SUBJECT: WATTS BAR NUCLEAR PLANT, UNIT 1 — SUMMARY OF CONFERENCE  
CALLS WITH TENNESSEE VALLEY AUTHORITY REGARDING THE CYCLE 6  
REFUELING OUTAGE STEAM GENERATOR TUBE INSPECTIONS (TAC NO.  
MC5629)

SUMMARY OF CONFERENCE CALLS  
TENNESSEE VALLEY AUTHORITY  
STEAM GENERATOR TUBE INSPECTION RESULTS  
FOR THE CYCLE 6 REFUELING OUTAGE  
WATTS BAR NUCLEAR PLANT, UNIT 1

- OD stress corrosion cracking axial indication dings in the cold leg:

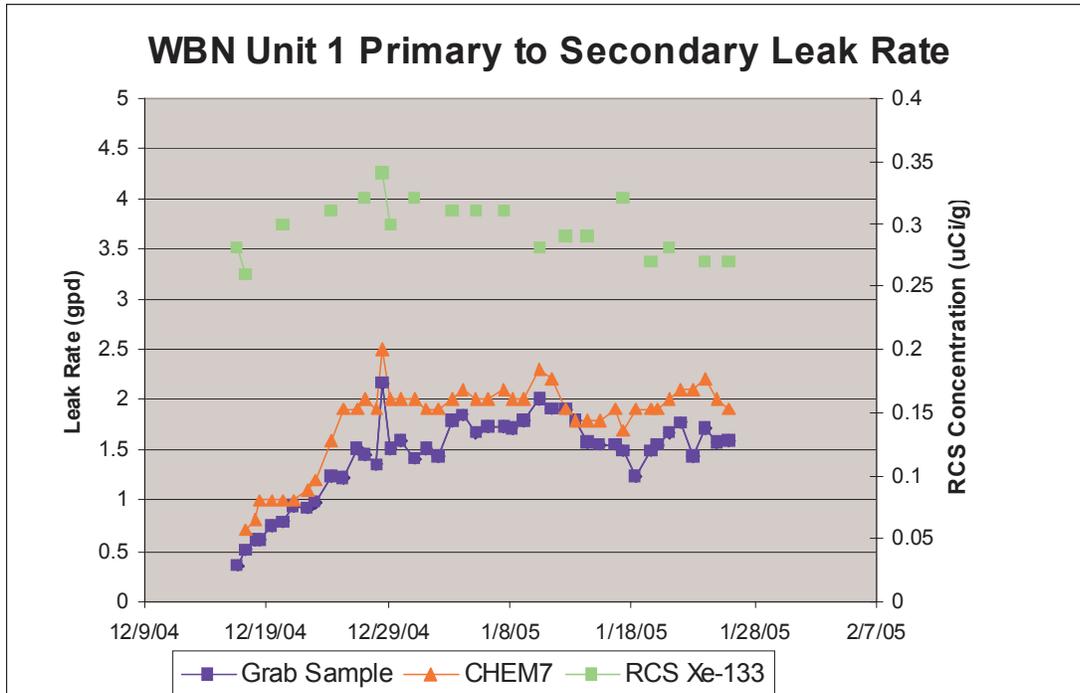
The initial scope of the inspection was a 20 percent sample of preheater dings above support plate CL 3. Based on the finding of an indication, the program was expanded to include 100 percent of pre-heater dings up to support plate CL 11. This expansion was based upon the experience at South Texas Project for detecting cracks in dings before these spread to higher regions in the SG. One additional crack in a ding was detected in support plate CL 3. These indications were not in situ tested since these were small indications and did not meet any screening criteria.
